**Re: Revised Visual Simulations  
Humboldt Bay Repowering Project (06-AFC-07)**

# **Humboldt Bay Repowering Project (06-AFC-7)**

**Supplemental Filing of November 19, 2007**

## **Revised Visual Simulations**

**FIGURE 8.13-5**  
**EXISTING VIEW AND VISUAL SIMULATION**  
**FROM NORTHBOUND HIGHWAY 101 - KOP1**  
 HUMBOLDT BAY REPOWERING PROJECT  
 HUMBOLDT COUNTY, CALIFORNIA

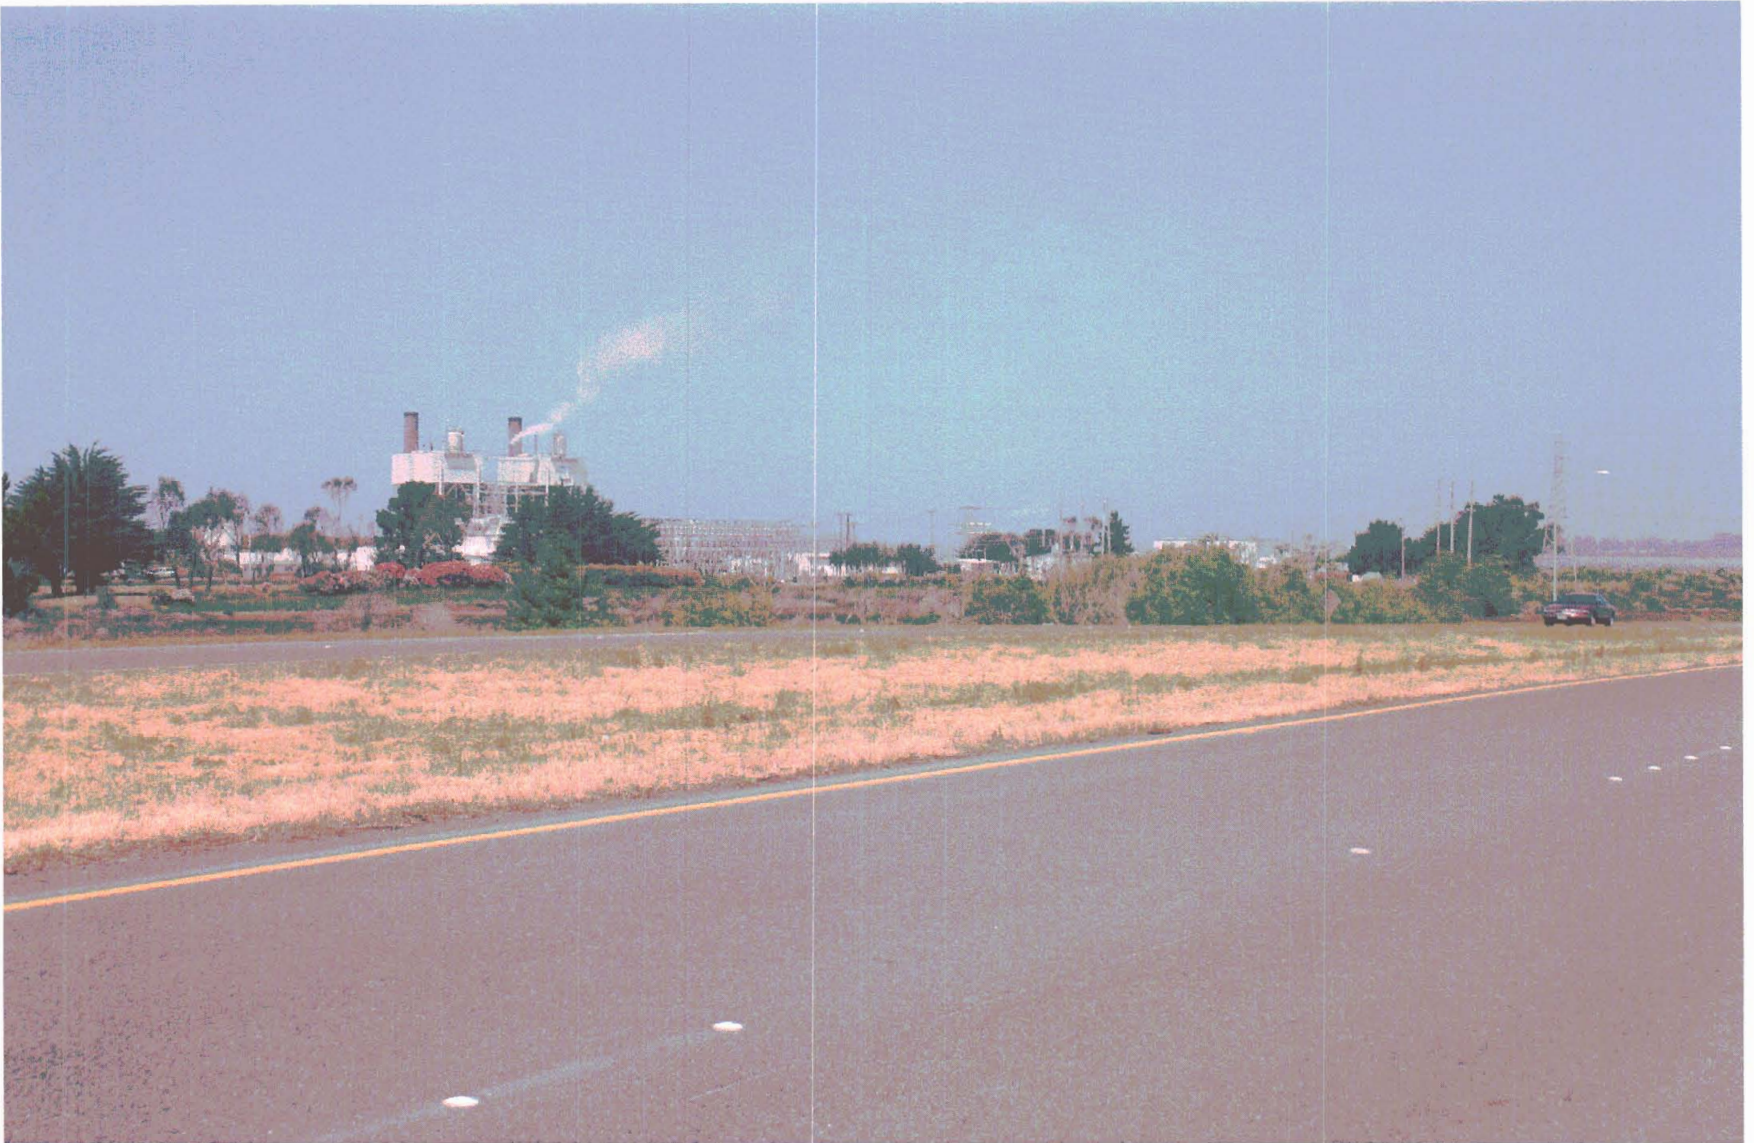
Attached are revised visual simulations filed in support of the Humboldt Bay Repowering Project (HBRP) Application for Certification (AFC) 06-AFC-07 before the California Energy Commission. The attached visual simulations correct and replace revised visual simulations that Pacific Gas and Electric Company (PG&E) filed on September 28, 2007 (Docket #42578). The simulations filed in September had been revised to depict the modified stack height, which changed from the 75-foot height described in the AFC, to 100 feet. The change in stack height resulted from additional air dispersion modeling analyses.

In subsequent discussions with the owner's engineer and equipment supplier, Wärtsilä Corporation, however, it was determined that the simulations filed in September do not show the metal stack support structure surrounding the stacks at the correct height. The stack support structure will increase in height along with the height of the stacks themselves and was not shown with this increase in the September 28 filing. For this reason, PG&E has prepared revised visual simulations showing the correct stack support structure heights. A revised simulation from Key Observation Point (KOP)-6 (South Spit Wildlife Area) has not been prepared because, from the distance between the project and the viewpoint from this KOP, the stacks appear relatively small and do not penetrate the background horizon, and the increase in stack height is not consequential.
